Addendum No. 1 to Contract Documents

Project	Water District No. 2 Distribution System Replacement	Project No.	8616265
Owner	Town of North Castle, New York	Federal Project No.	--
Contract No.	1 - General	Date	June 3, 2014

Addendum No. 1 to Contract Documents
Water District No. 2 Distribution System Replacement
Town of North Castle, NY
Contract No. 1-General
GHD Project No. 8616265
June 3, 2014

2
C046
SCALE: NONE

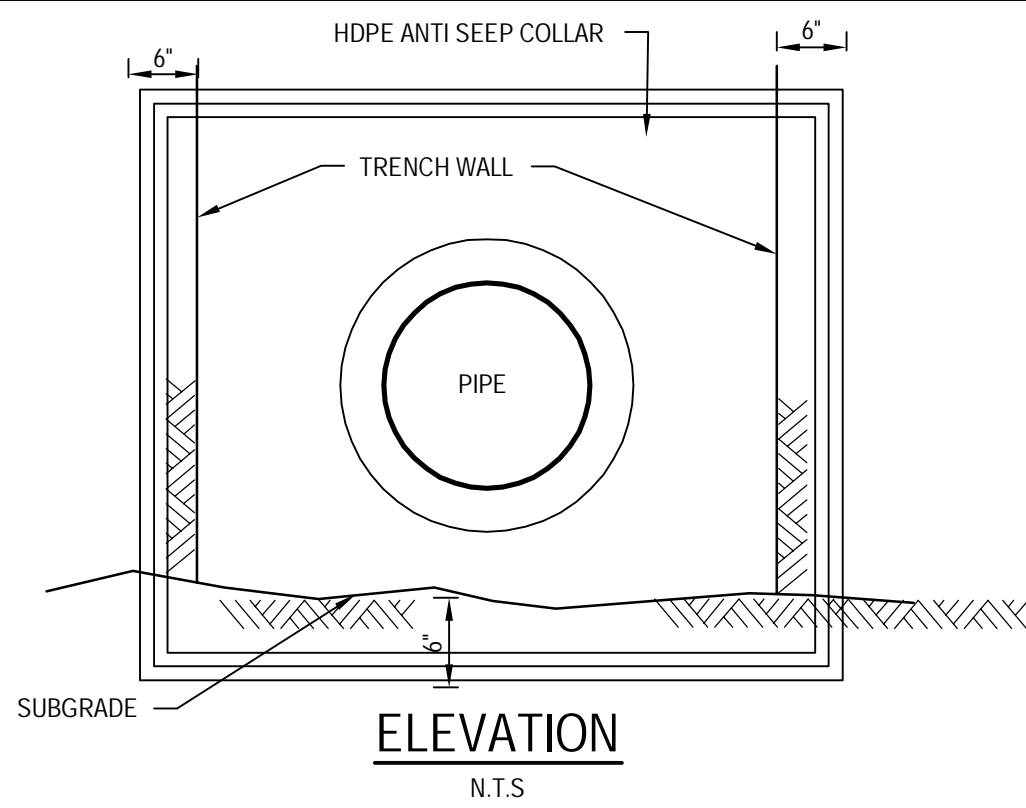
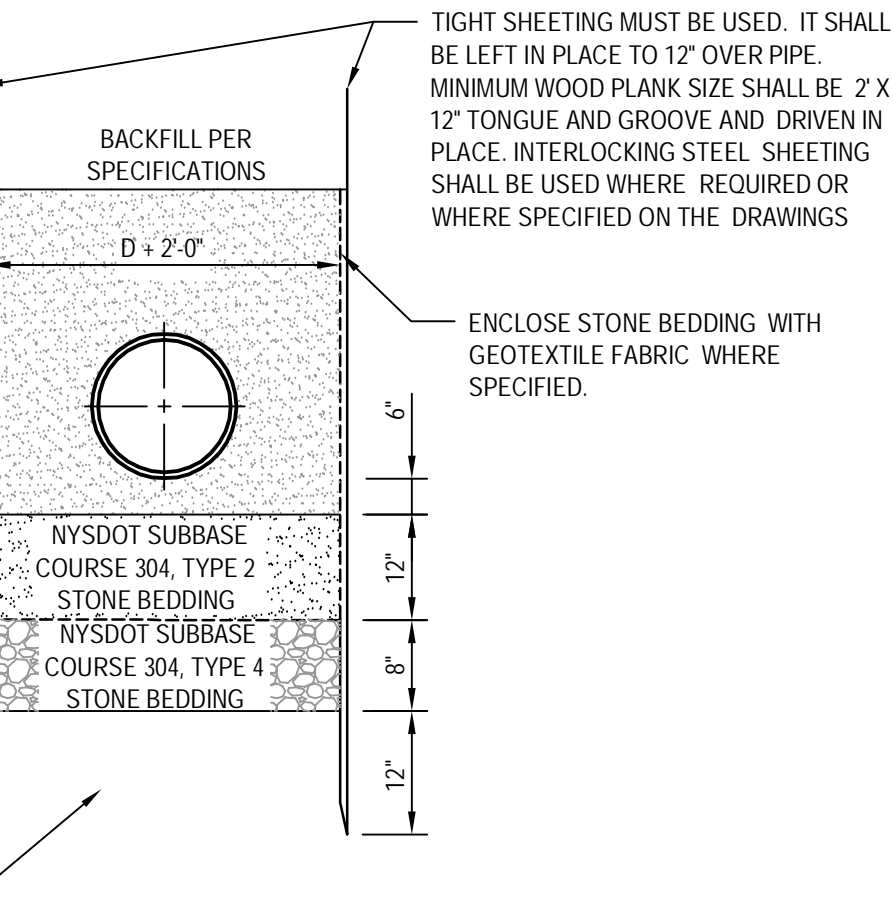
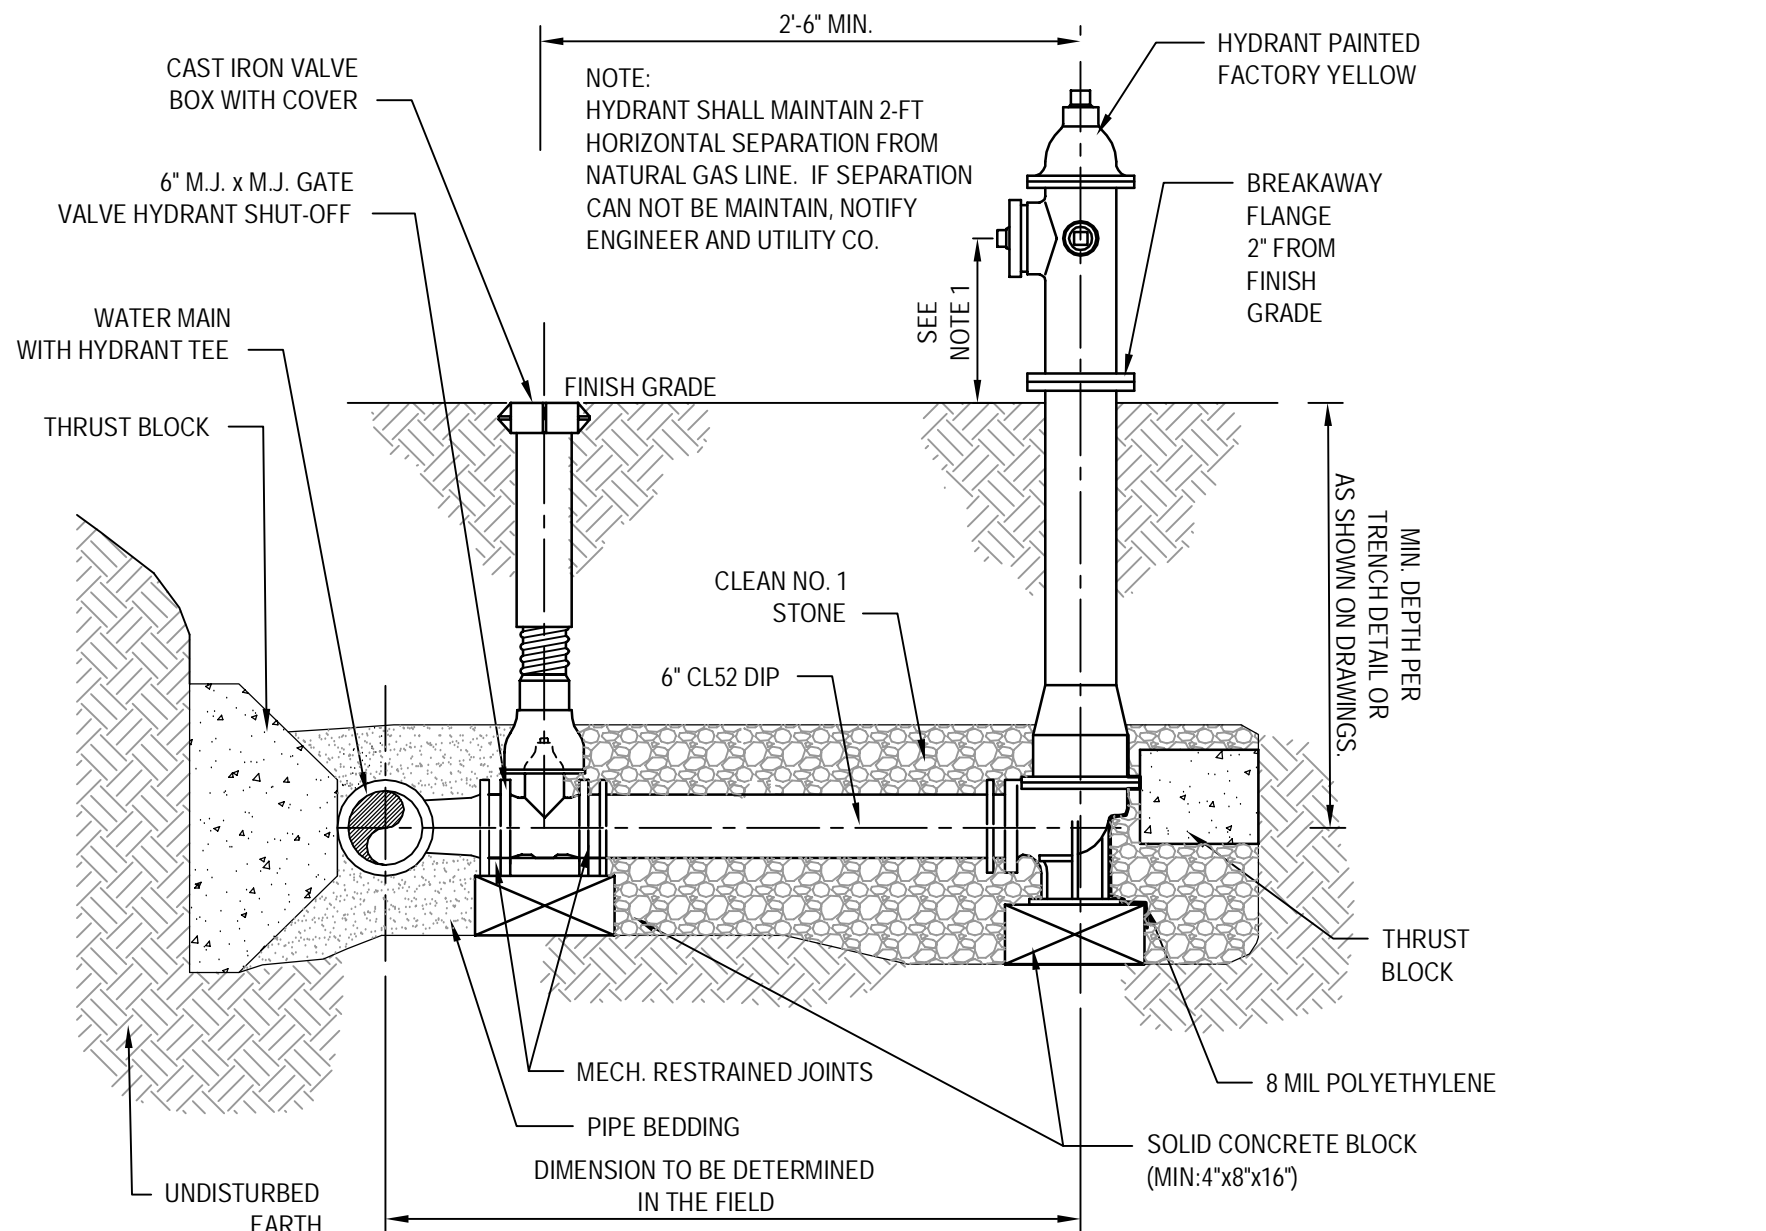
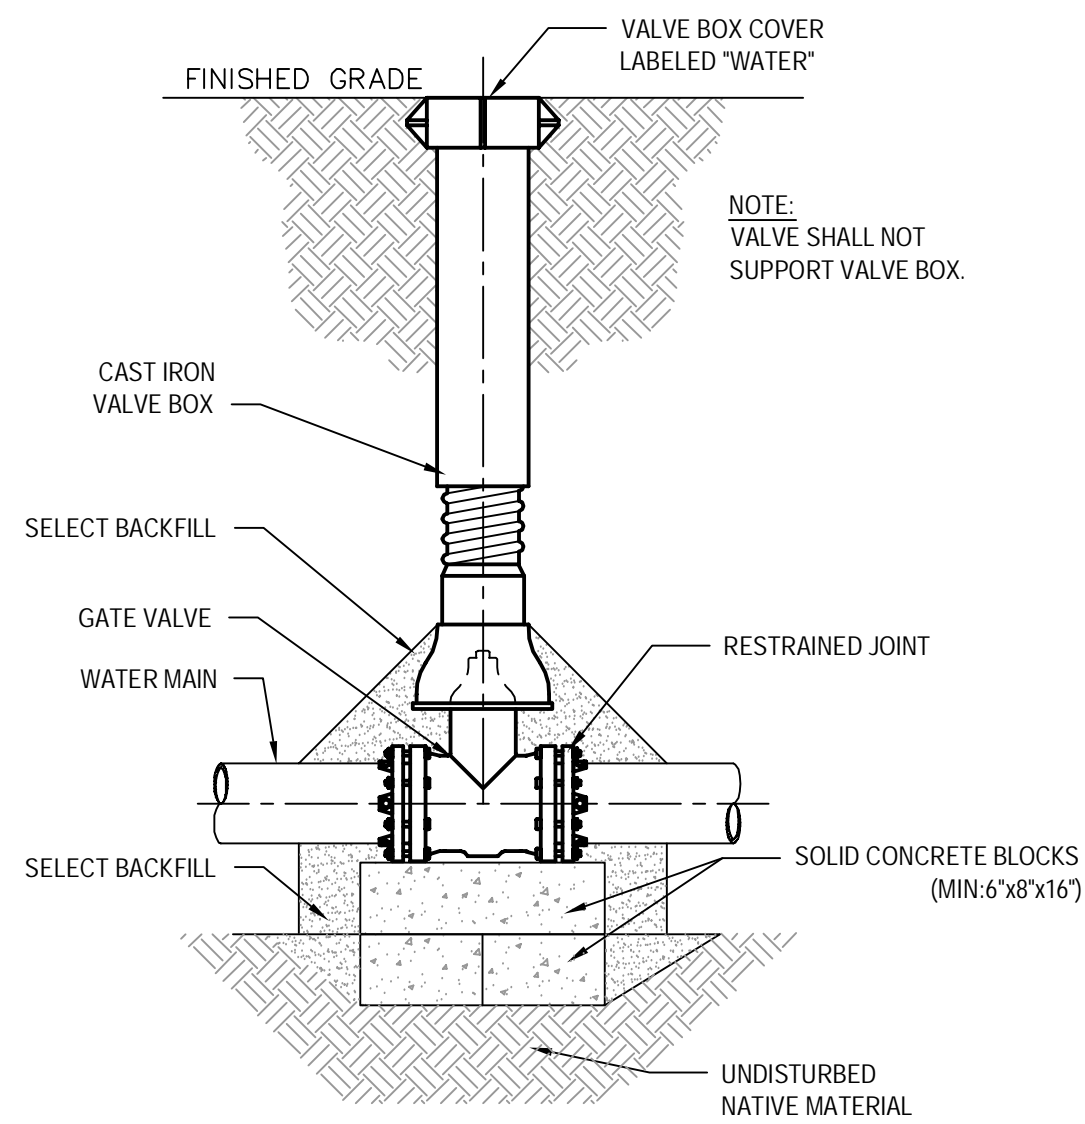
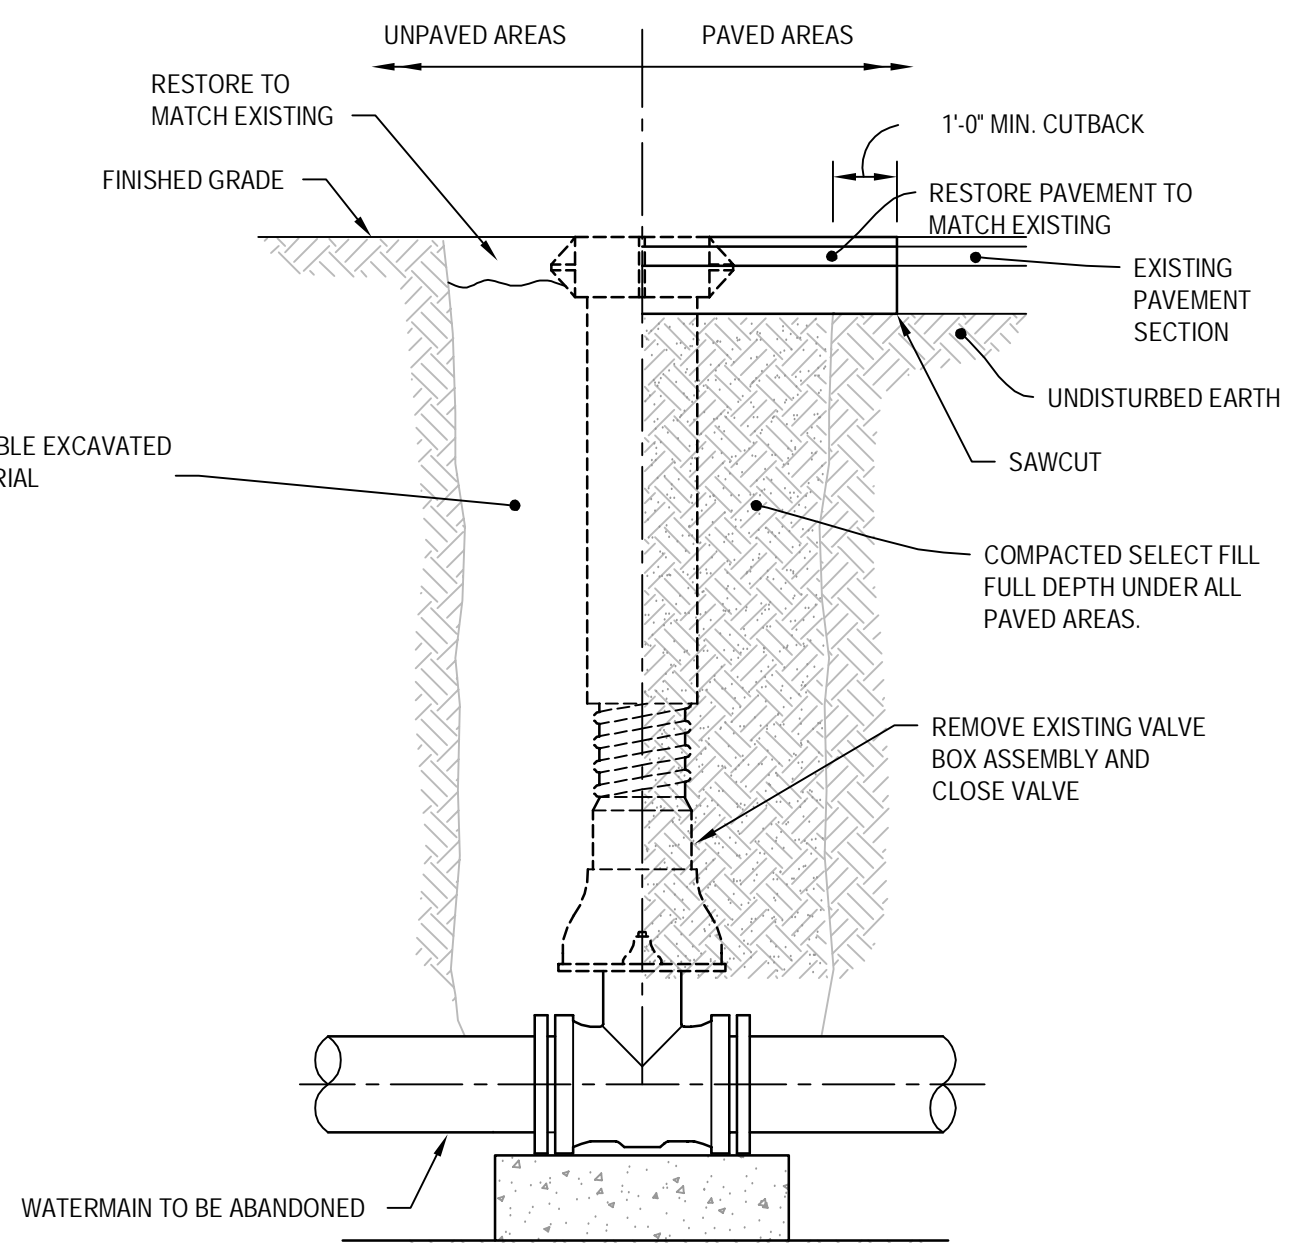
REMOVE Drawing C046 and **REPLACE** with Drawing C046 (Attachment No. 8).

37 STANDARD DETAIL RESTRAINED JOINT SCHEDULE
C049 SCALE: NONE

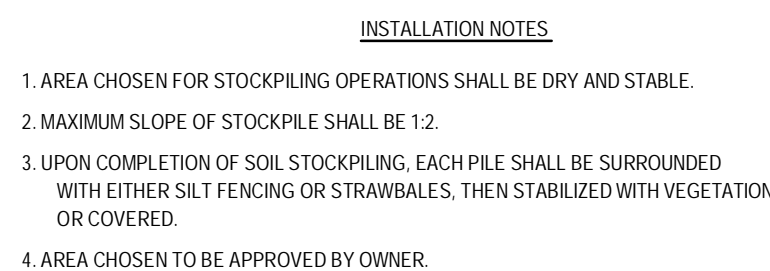
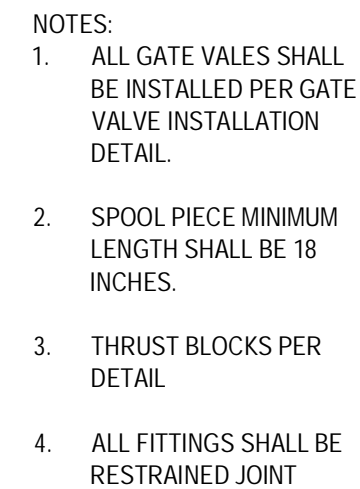
1. Detail 29 on Sheet C049 is for an anchor collar. Is this only applicable to reducers?

Clarification: Detail 29 is for reducers only.
